Tiffin Regular City Council Meeting
Tiffin Regular City Council Meeting
September 01, 2026 07:00 pm

DATE:	August 27, 2026
AGENDA ITEM:	Approval of Change Order #3 – Tricon Construction Group – Water Treatment Facility Upgrade
ACTION:	Motion

CHANGE ORDER NO.: 3

Owner:	City of Tiffin	Owner's Project No.:	
Engineer:	MSA Professional Services	Engineer's Project No.:	13603021
Contractor:	Tricon Construction Group	Contractor's Project No.:	25-012-IA
Project:	Tiffin WTF Upgrade		
Contract Name:	13603021 – Tiffin WTF Upgrade		
Date Issued:	August 19, 2026	Effective Date of Change Order:	September 1, 2026

EXISTING WTP
PROPOSED FLOOR PLAN

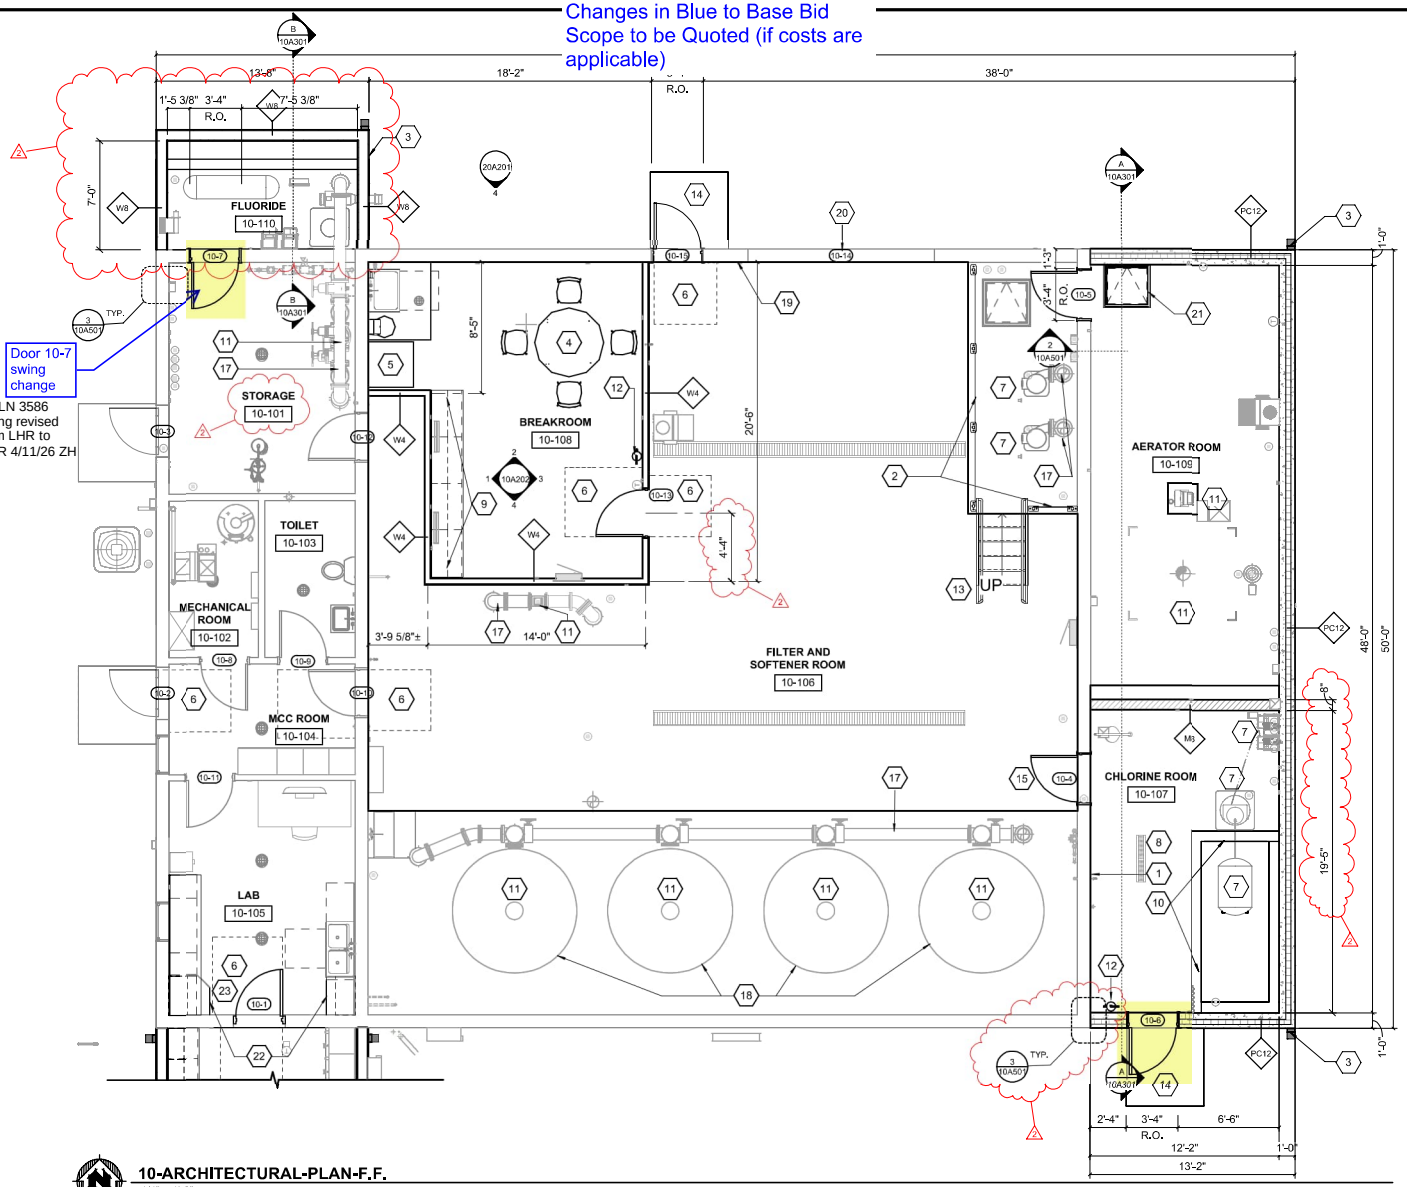
Changes in Blue to Base Bid
Scope to be Quoted (if costs are applicable)

RO BUILDING
PROPOSED PLUMBING ABOVE GRADE FLOOR PLAN

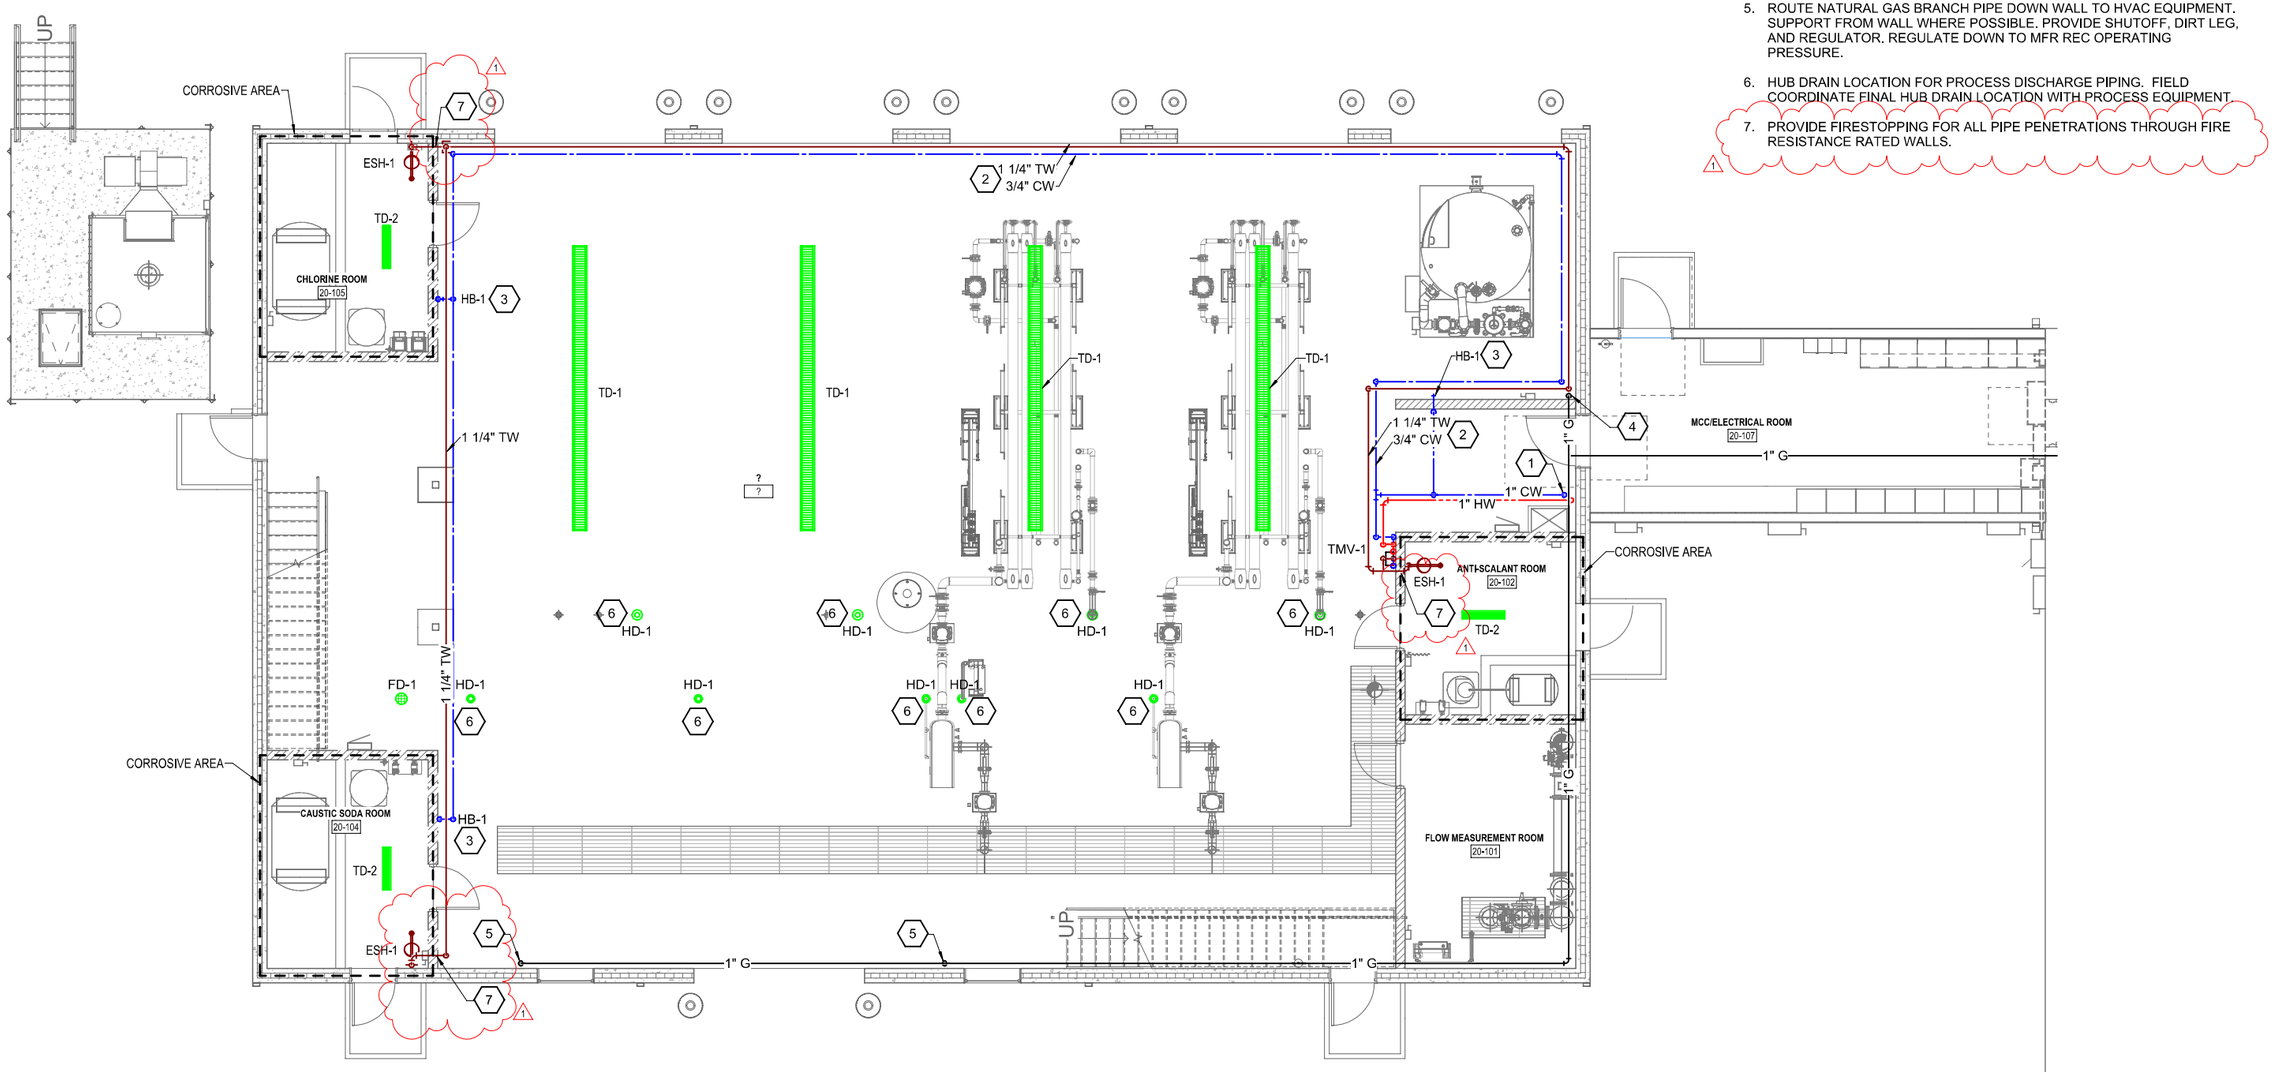
1) Provide firestop submittal for all rated penetrations. <7/21/2025 NS>
   Piping that penetrates through the 1-hour control areas have been identified on the drawings provided. (MSA)

1. NEW HOT AND COLD WATER PIPING UP THROUGH FLOOR. ROUTE UP INSIDE WALL AND HIGH AS POSSIBLE. SUPPORT FROM WALL.
2. PIPING SHOWN IN APPROXIMATE LOCATION. OFFSET PIPING AS NECESSARY TO NEW FIXTURES. SUPPORT PIPING FROM WALL WHERE POSSIBLE.
3. ROUTE 3/4" DOWN TO CONNECTION ON HOSE BIBB. PROVIDE LINE SIZED SHUTOFF VALVE IN VERTICAL.
4. ROUTE PIPING UP UP WALL TO CEILING. SUPPORT VERTICAL PIPING FROM WALL.
5. ROUTE NATURAL GAS BRANCH PIPE DOWN WALL TO HVAC EQUIPMENT. SUPPORT FROM WALL WHERE POSSIBLE. PROVIDE SHUTOFF, DIRT LEG, AND REGULATOR. REGULATE DOWN TO MFR REC OPERATING PRESSURE.
6. HUB DRAIN LOCATION FOR PROCESS DISCHARGE PIPING. FIELD COORDINATE FINAL HUB DRAIN LOCATION WITH PROCESS EQUIPMENT.
7. PROVIDE FIRESTOPPING FOR ALL PIPE PENETRATIONS THROUGH FIRE RESISTANCE RATED WALLS.

OVERALL FLOOR PLAN (STRUCTURES 10 AND 20) AND LIFE SAFETY PLAN

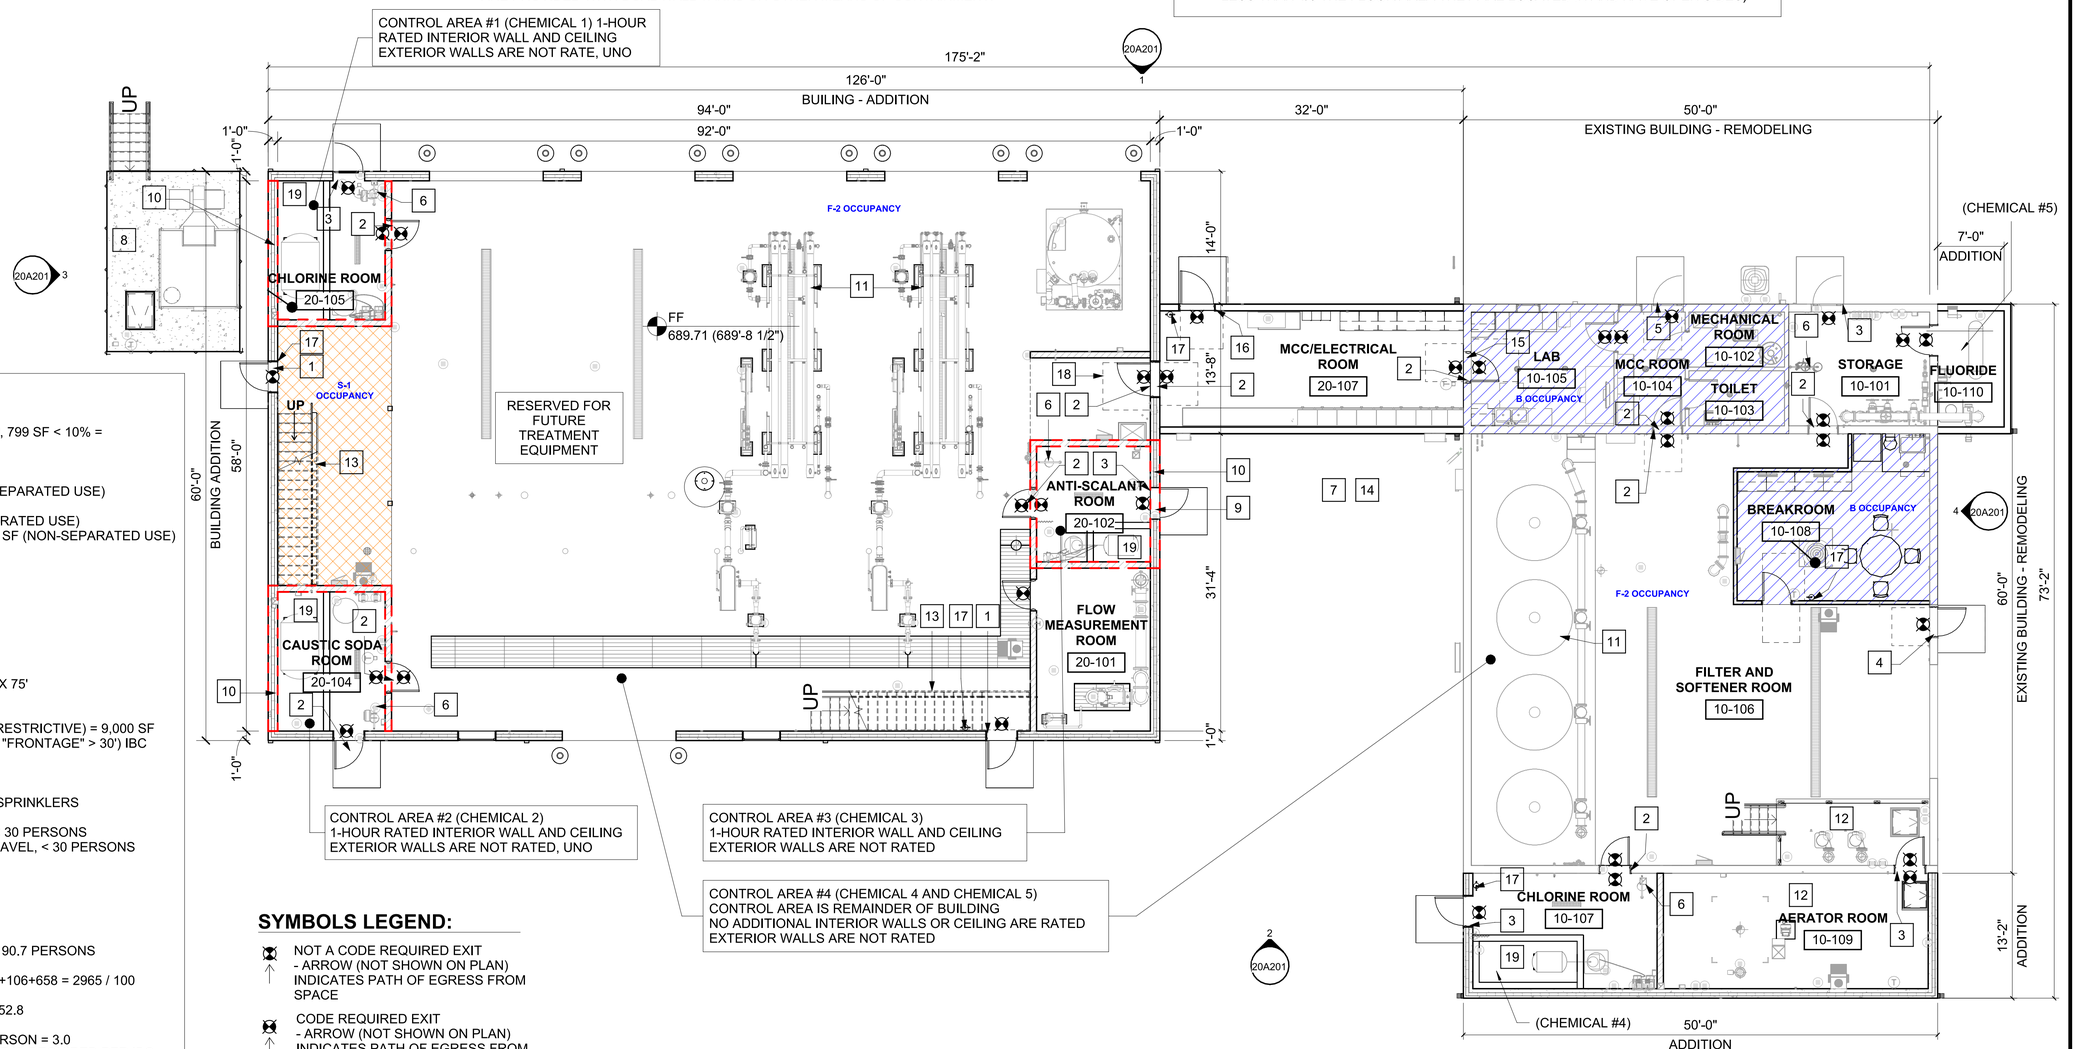
2) Provide a Life Safety Plan for this project including area Uses and Occupancy Classifications, Occupant Loads, Egress Travel distances, Common Path of Travel distances where applicable, Accessible routes, Exit locations and sizing, Fire Extinguisher and fire protection elements, etc. <7/21/25 NS>

Life safety plans have been included for your review. (MSA)
